RE: **Lot 13 Block 10, Volcano Cliffs, Unit 22, SAD 228
6300 Petirrojo NW
Grading and Drainage Plan
Engineers Stamp Date 2/10/20 (D10D003F13A)**

DRAINAGE AND TRANSPORTATION INFORMATION SHEET (REV 6/2018)

ENGINEER'S SEAL 2/10/20 DAVID SOULE P.E. #14522	6300 PETIRROJO	DRAWN BY WCWJ DATE 2-04-20 21721-LAYOUT-3-20-17
	GRADING AND DRAINAGE PLAN	SHEET #
	 1606 CENTRAL AVENUE SE SUITE 201 ALBUQUERQUE, NM 87106 (505) 872-0988	JOB # 21721

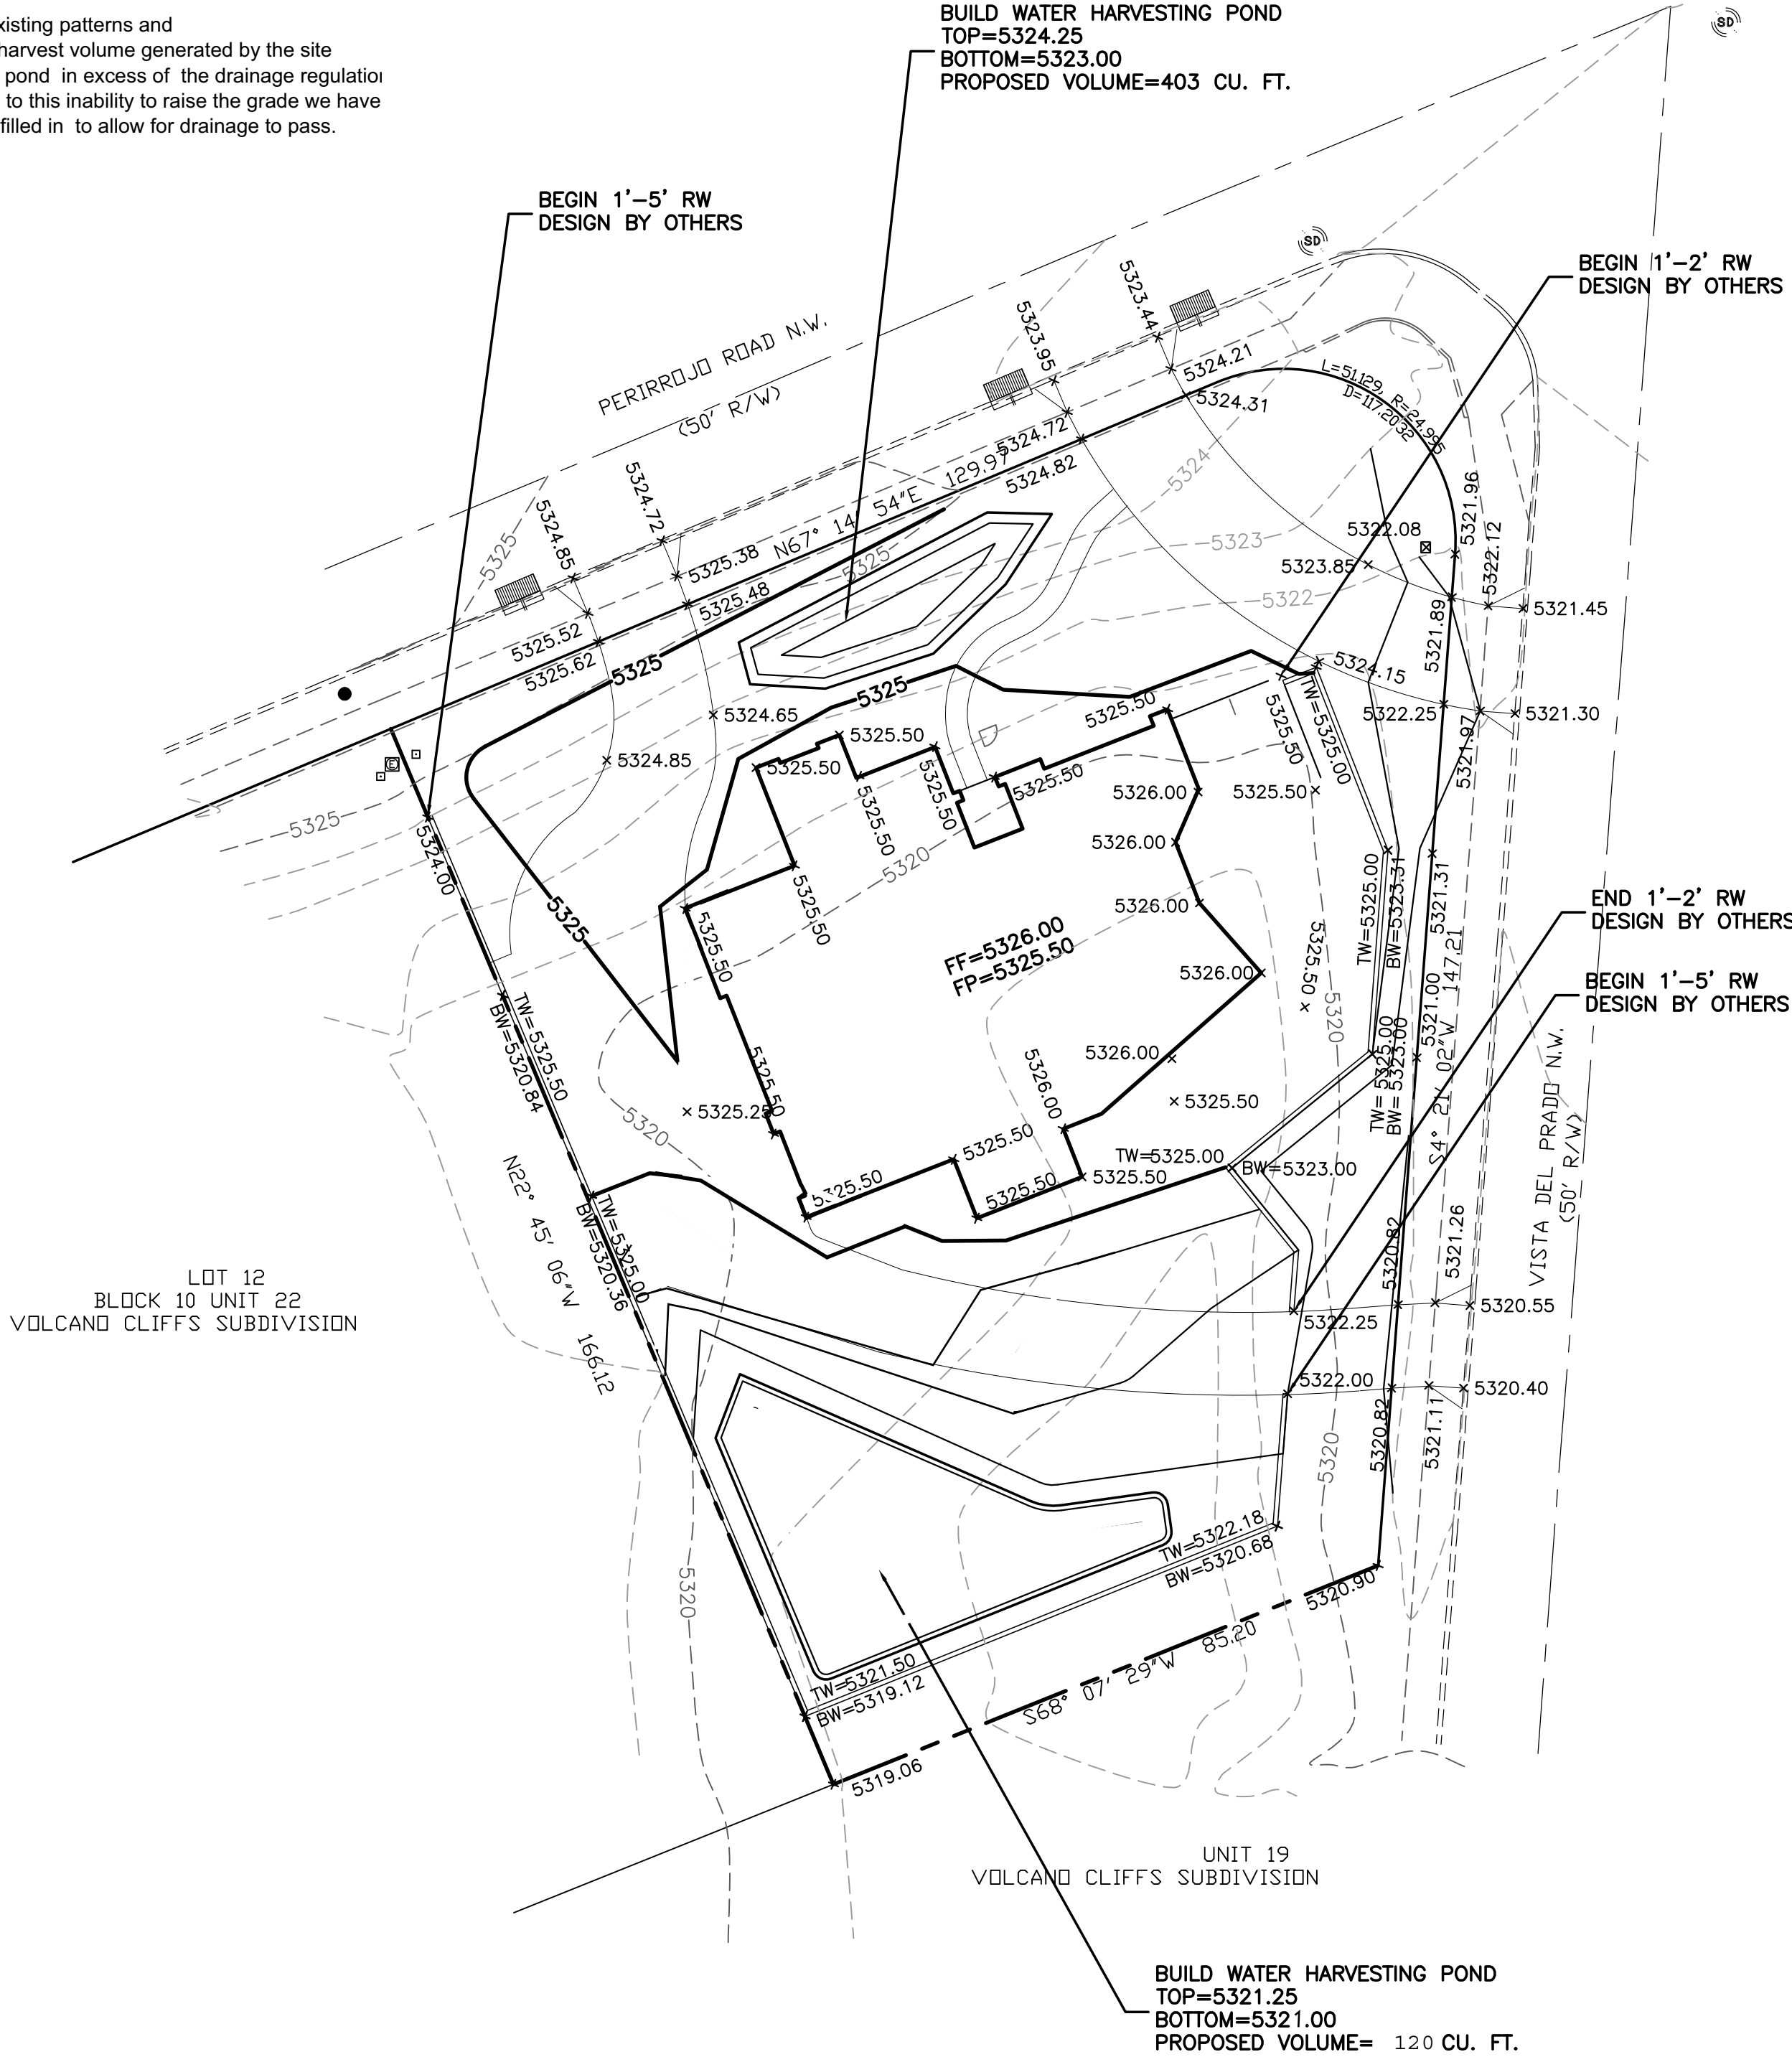
Prior to Building permit approval a Pad Certification will be required, provided by the Engineer or a registered Land Surveyor.

Advise the owner contractor not to use dirt as a ramp to climb the curb, use lumber or crusher fines for this purpose.

Reiterate to the Owner/Contractor that a separate permit for a garden/retaining wall must be obtained with the approved G&D plan and Pad Certification. Also, if a swimming pool is to be placed the grading and drainage plan will change and will need to be resubmitted.

Prior to Certificate of Occupancy release, Engineer Certification per the DPM checklist is required.
